ADDENDUM NO. 01

TO: PLANS AND SPECIFICATIONS FOR STATE OF MISSOURI

HVAC Improvements for Infection Control
Warrensburg Veterans Home
Warrensburg, Missouri
PROJECT NO.: U2301-07

MECHANICAL
CONTROLS
DIAGRAMS

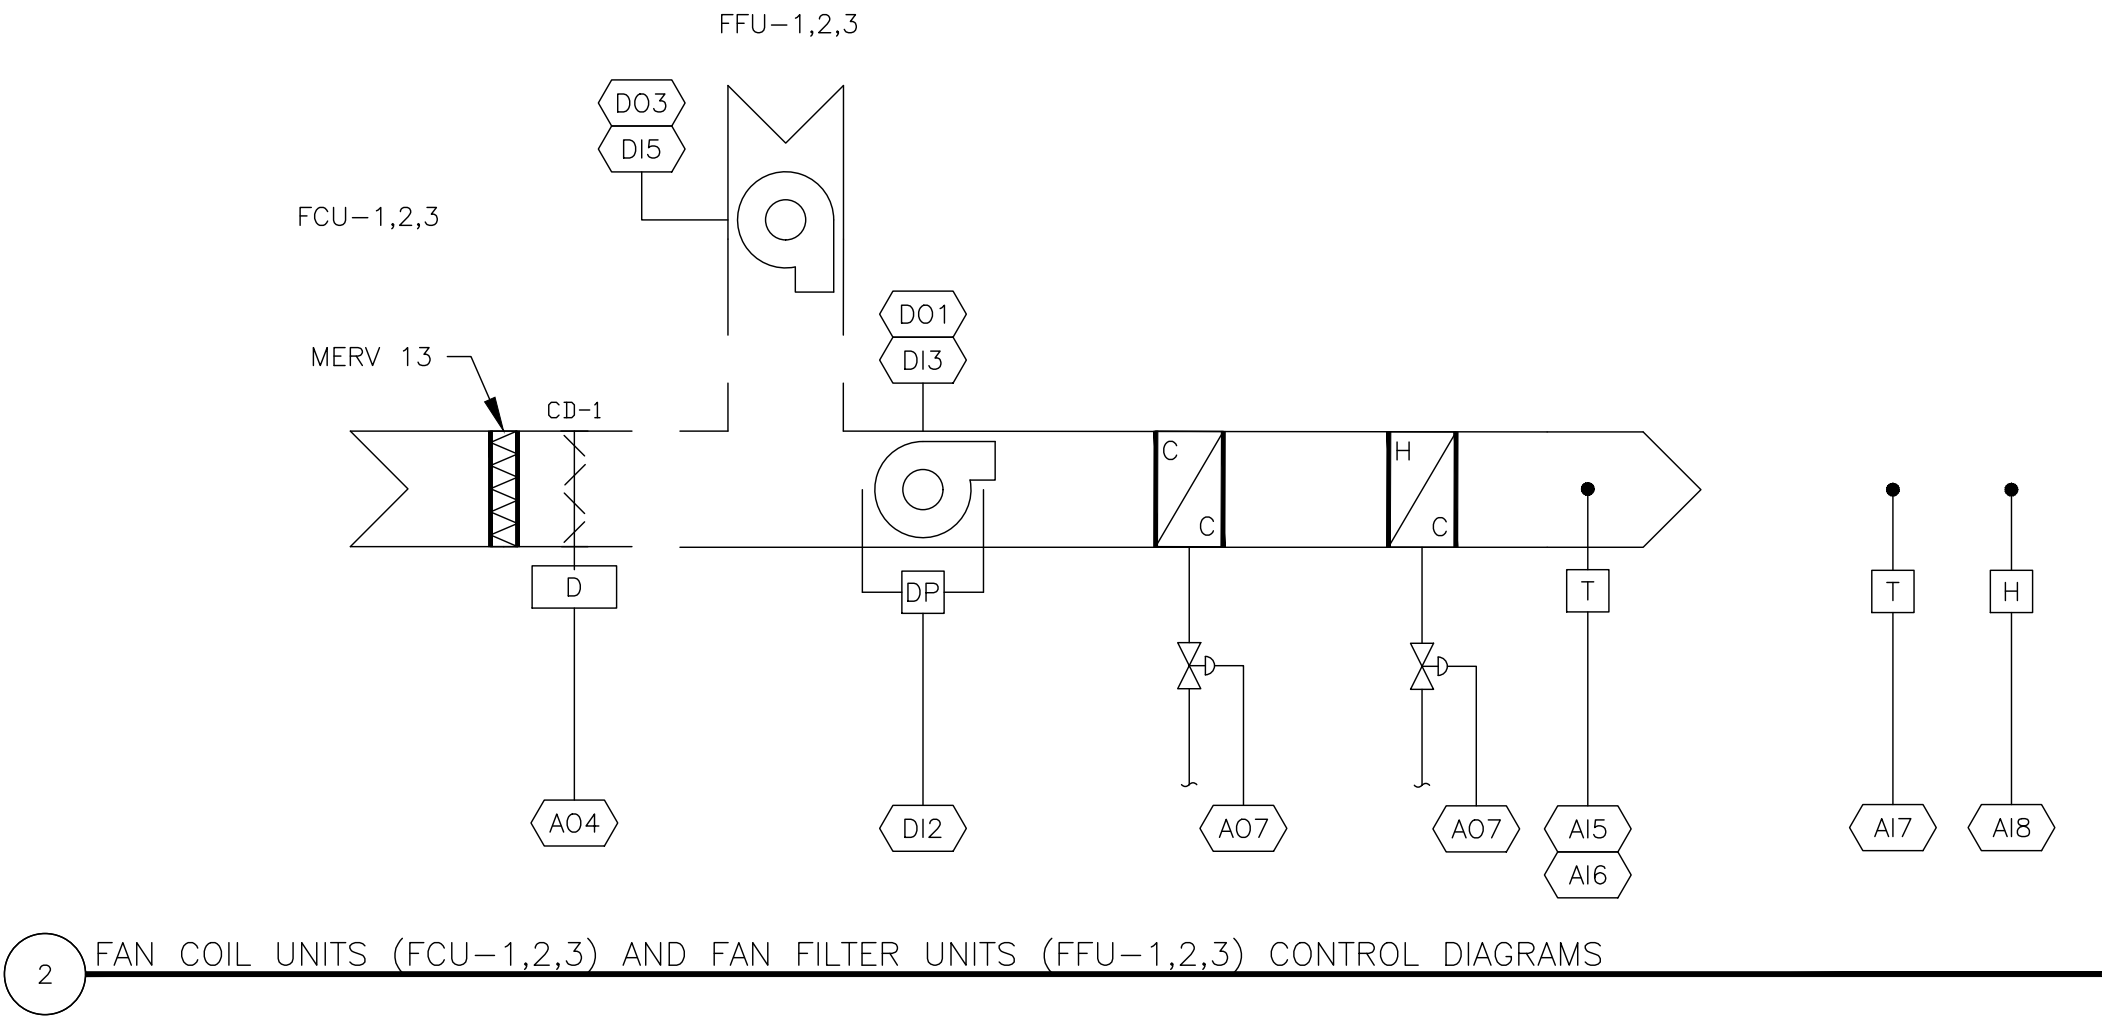
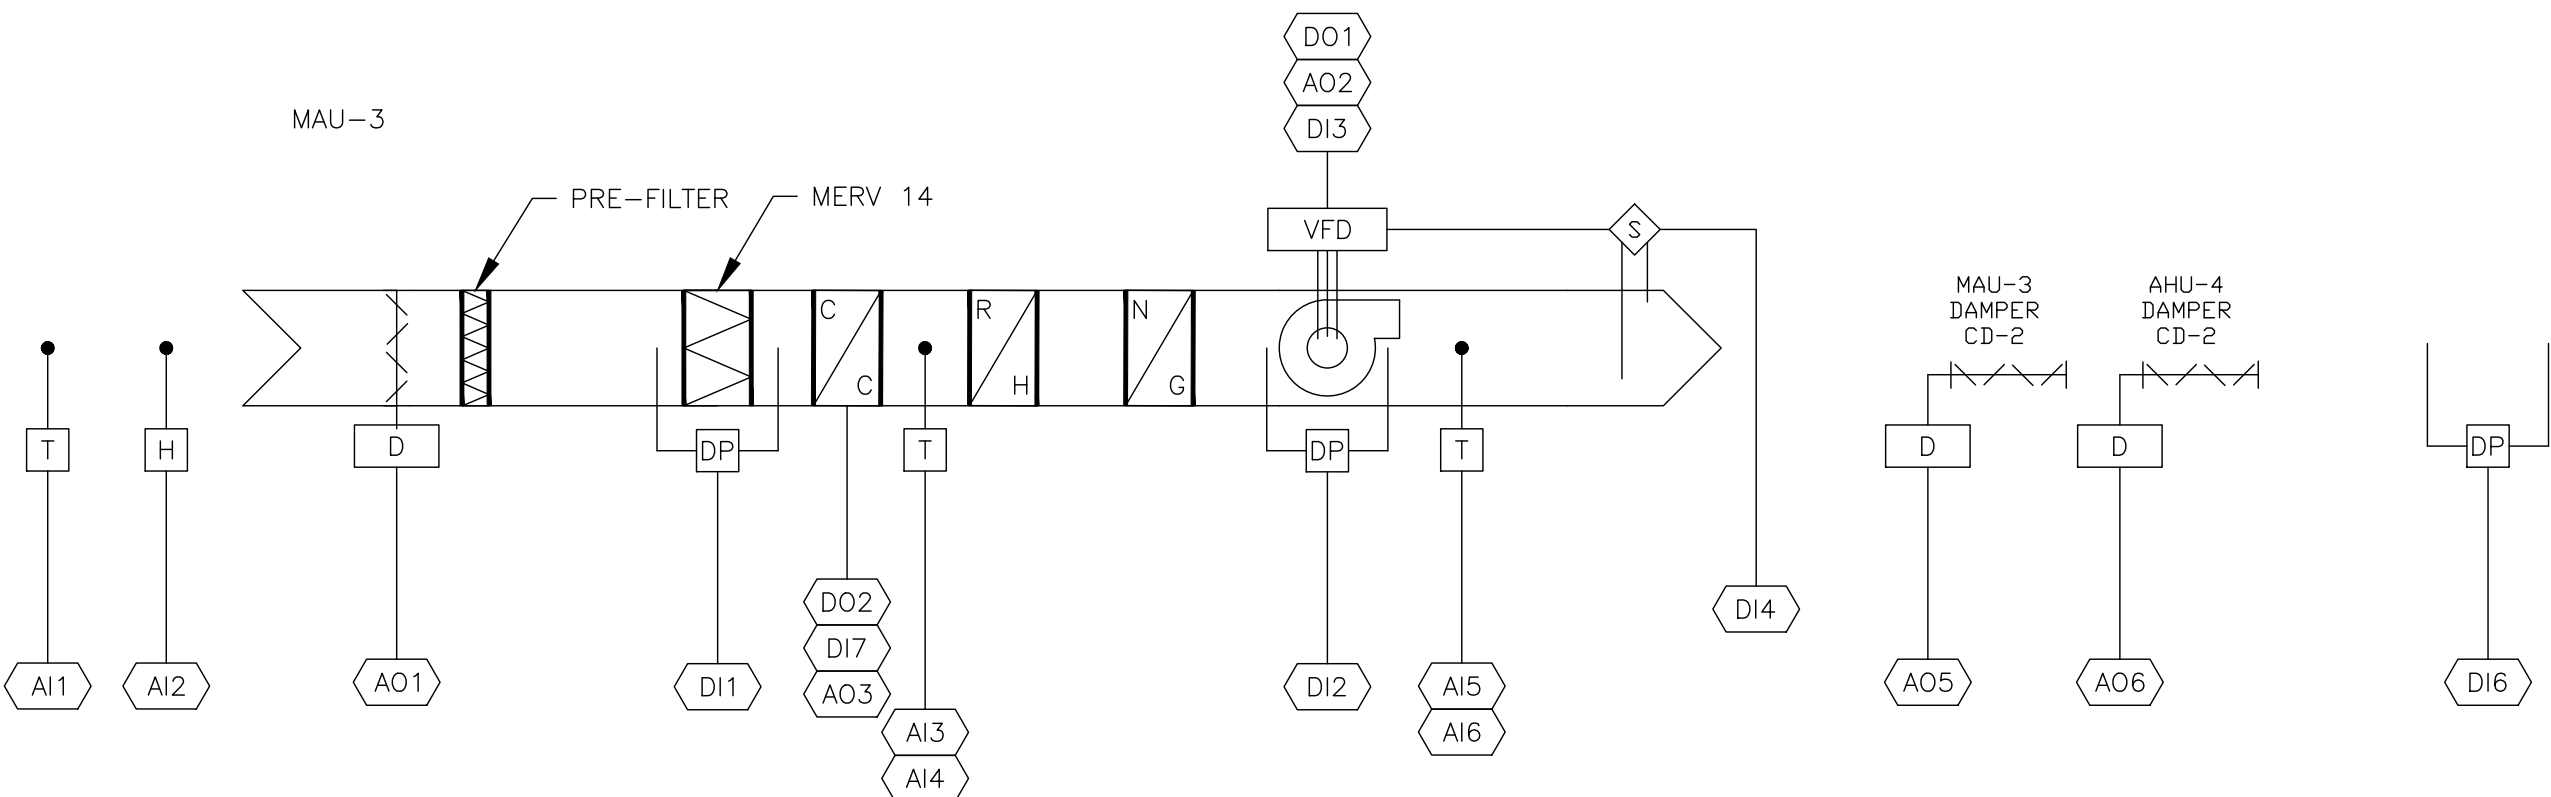
- a. Revise schedule notes.
- 7. Sheet M-602
 - a. Revise Sequence of Operation Alarms.
- 8. Sheet E-101
 - a. REVISE location of existing 2-pole exhaust fan contactor from the north wall in Mechanical Room A315 to on the AHU-4 next to the supply fan starter.

PARTIAL FIRST FLOOR PLAN
ELECTRICAL RENOVATION
SCALE: 1/8"=1'-0"

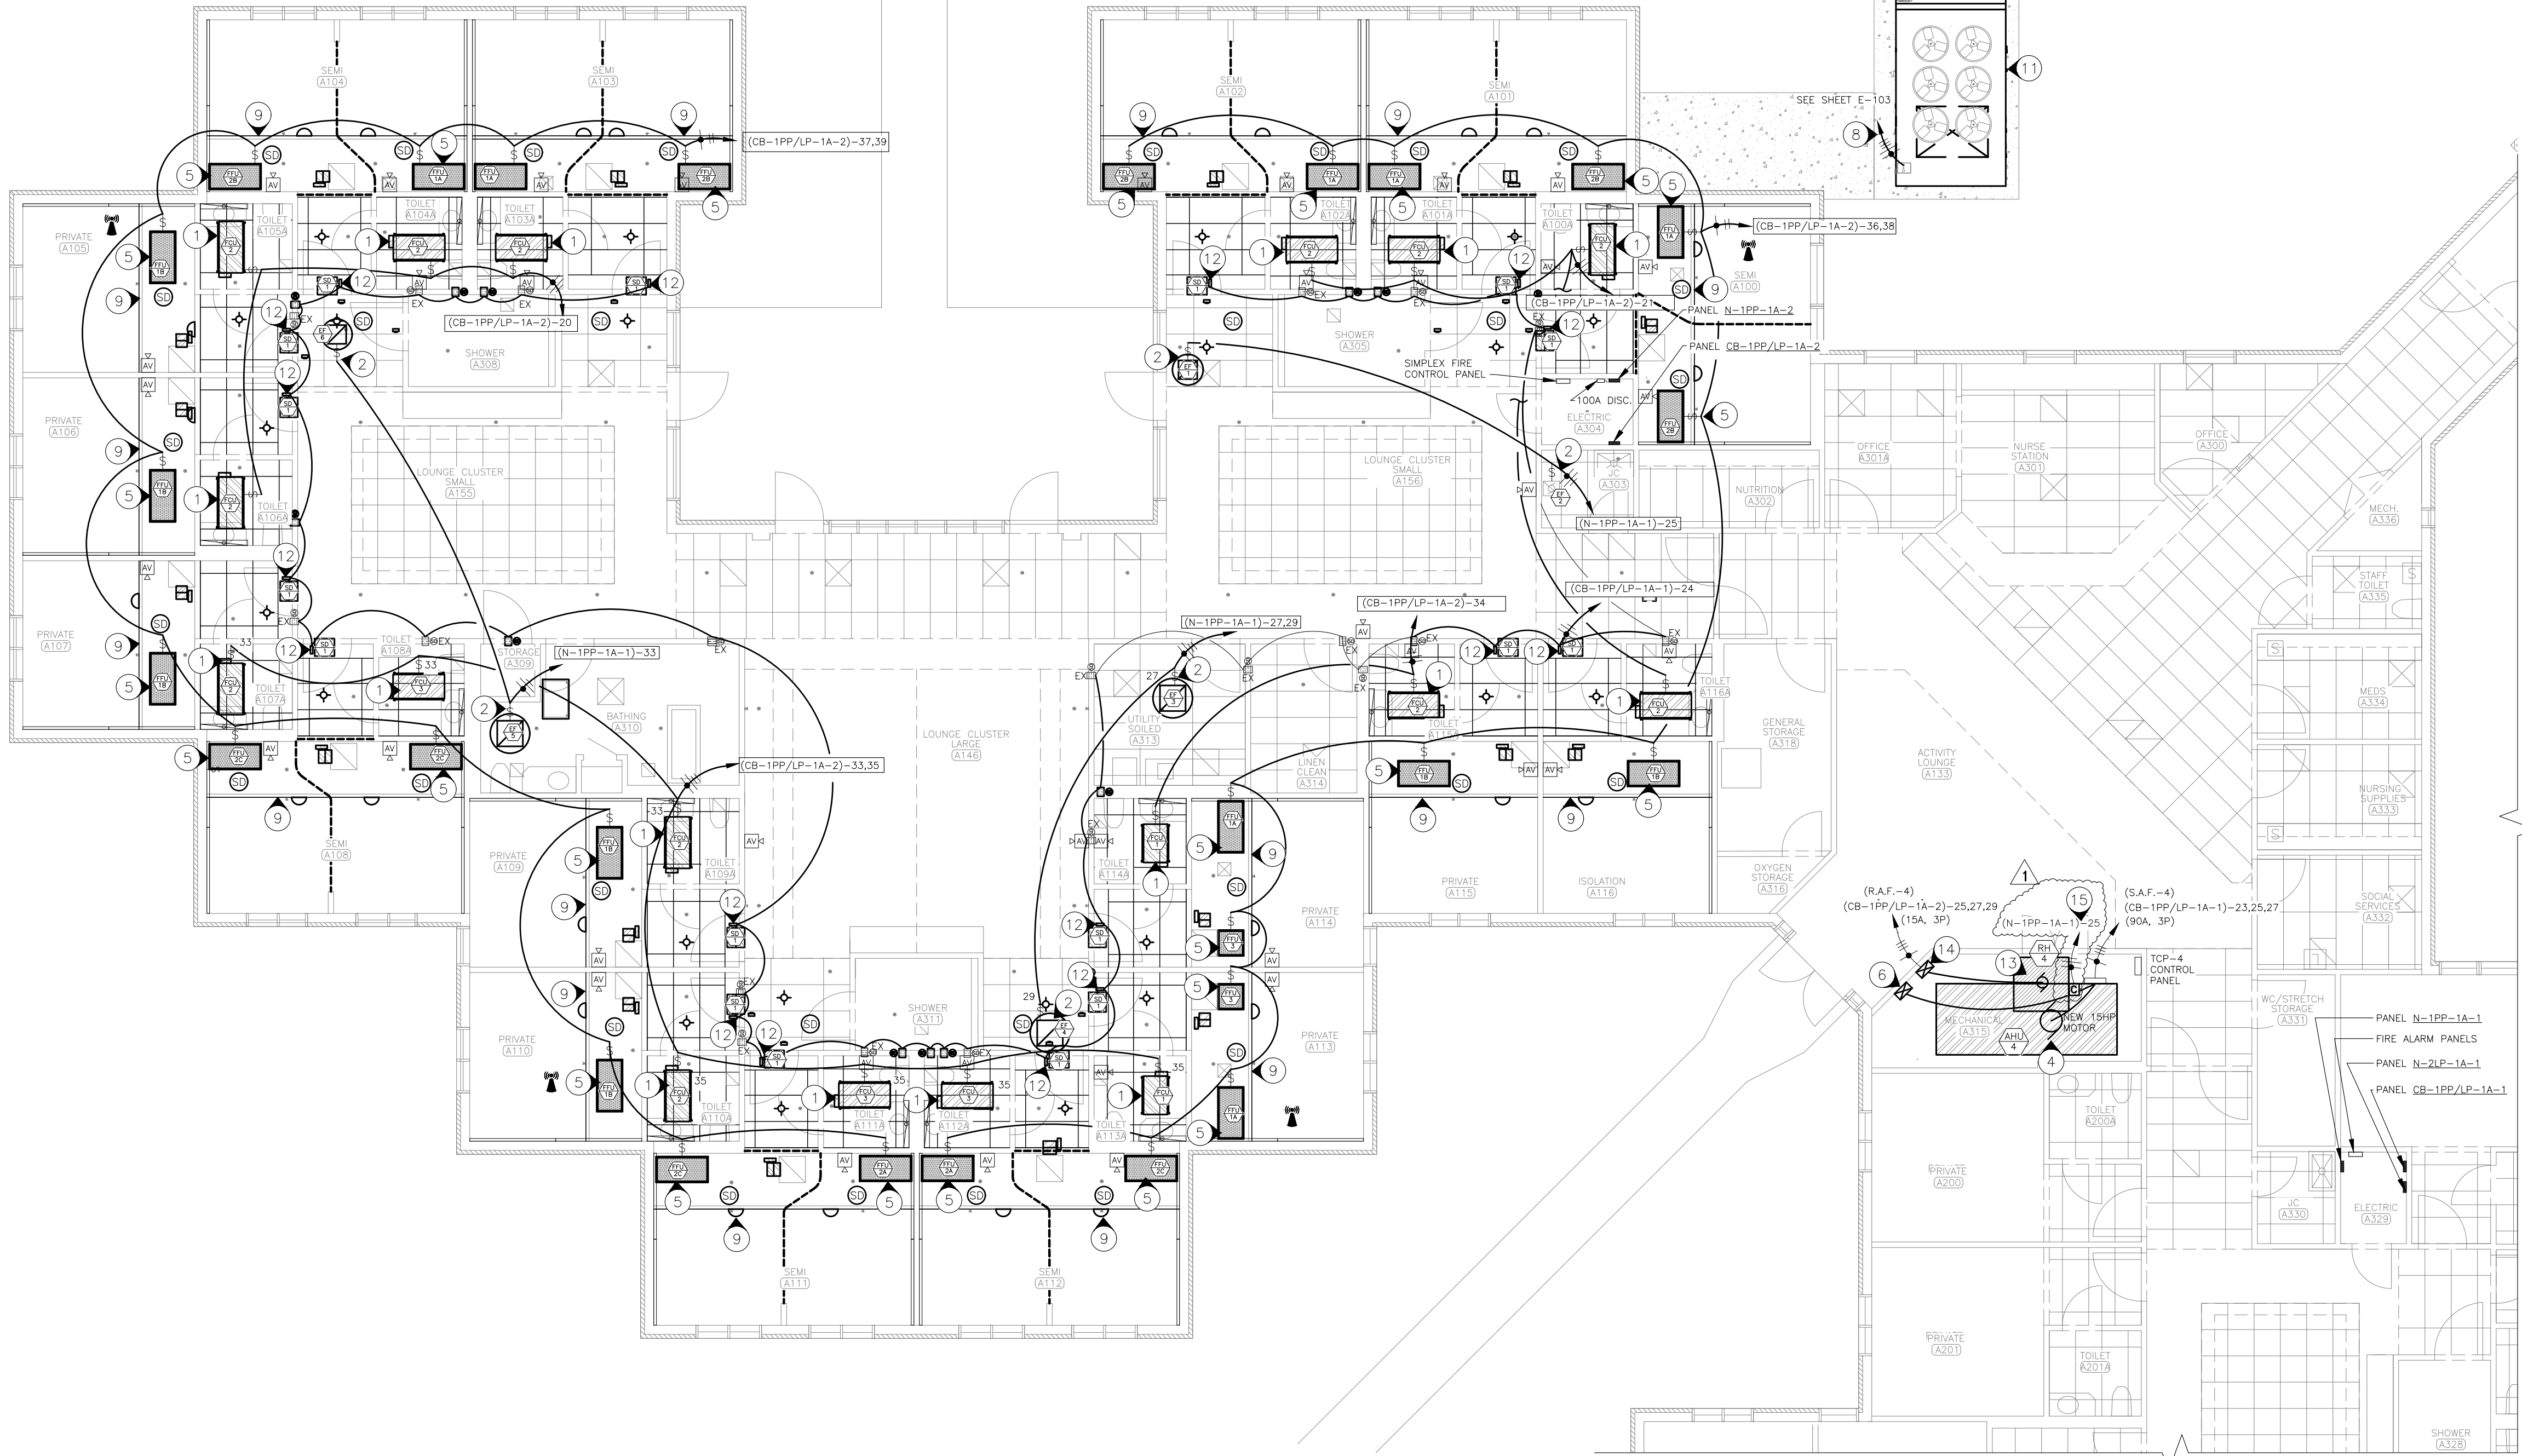
- 9. Sheet E-102
 - a. REVISE drawing to add existing contactor location on AHU-4.
 - b. REVISE construction note 2 to read: ELC TO PROVIDE WIRE AND CONDUIT AND CONNECT POWER TO NEW FACTORY PROVIDED DISCONNECT AS SHOWN. RUN POWER THROUGH NEW CONTACTOR IN MECHANICAL ROOM A315. SEE NOTE 15.

- c. ADD construction note 15: ELC TO ADD 4-POLE CONTACTOR IN EXISTING CONTACTOR ENCLOSURE. MAKE ALL WIRING CONNECTIONS TO NEW EXHAUST FANS AS SHOWN. CONTACTOR TURNS EXHAUST FANS ON WHEN AHU-4 IS ON. CIRCUITING FOR POWER TO CONTACTOR TO REMAIN. IF ENCLOSURE DOES NOT HAVE ROOM FOR A NEW 4-POLE CONTACTOR, ELC TO PROVIDE AND INSTALL ADDITIONAL ENCLOSURE AS NEEDED.

- 1 ELC TO EXTEND AND CONNECT POWER TO NEW FAN COIL UNITS FACTORY PROVIDED DISCONNECT.
- 2 ELC TO PROVIDE WIRE AND CONDUIT AND CONNECT POWER TO NEW FACTORY PROVIDED DISCONNECT AS SHOWN. RUN POWER THROUGH NEW CONTACTOR IN MECHANICAL ROOM A-315. SEE NOTE 15.

- 15 ELC TO ADD 4-POLE CONTACTOR IN EXISTING CONTACTOR ENCLOSURE. MAKE ALL WIRING CONNECTIONS TO NEW EXHAUST FANS AS SHOWN. CONTACTOR TURNS ON EXHAUST FANS WHEN AHU-4 IS ON. CIRCUITING FOR POWER TO CONTACTOR TO REMAIN. IF ENCLOSURE DOES NOT HAVE ROOM FOR NEW 4-POLE CONTACTOR, ELC TO PROVIDE AND INSTALL ADDITIONAL ENCLOSURE AS NEEDED.
